Intel[®] Pentium[®] III Processor

Specification Update

August 2008

Revision 060

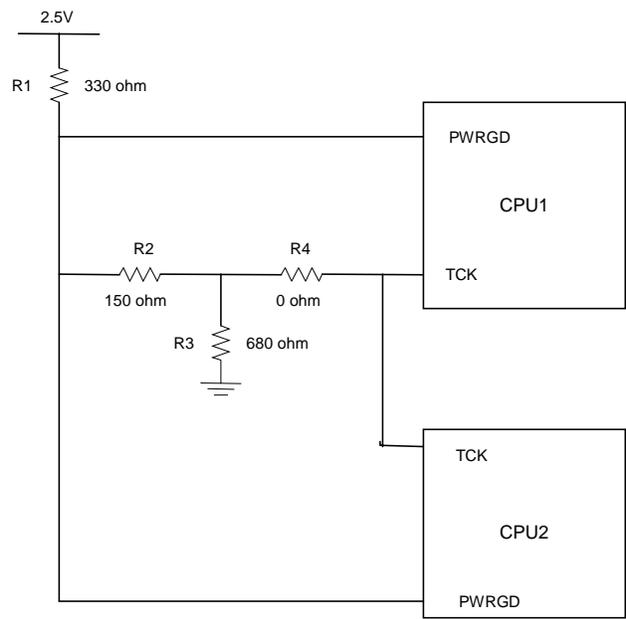
Problem: The internal control register bit responsible for operation of the Thermtrip circuit functionality may power up in a non-initialized state. As a result, THERMTRIP# may be incorrectly asserted during de-assertion of RESET# at nominal operating temperatures. When THERMTRIP# is asserted as a result of this erratum, the processor may shut down internally and stop execution but in few cases continue to execute.

Implication: This issue can lead to intermittent system power-on boot failures. The occurrence and repeatability of failures is system dependent, however all systems and processors are susceptible to failure. In addition, the processor may fail to stop execution during the event of a valid THERMTRIP# assertion resulting in the potential for permanent processor damage

Workaround: To prevent the risk of power-on boot failures or catastrophic thermal failures, a platform workaround is required. The system must provide a rising edge on the TCK signal during the power-on sequence that meets all of the following requirements:

- Rising edge occurs after Vcc_core is valid and stable
- Rising edge occurs before or at the de-assertion of RESET#
- Rising edge occurs after all Vref input signals are at valid voltage levels
- TCK input meets the Vih min and max spec as mentioned in EMTS
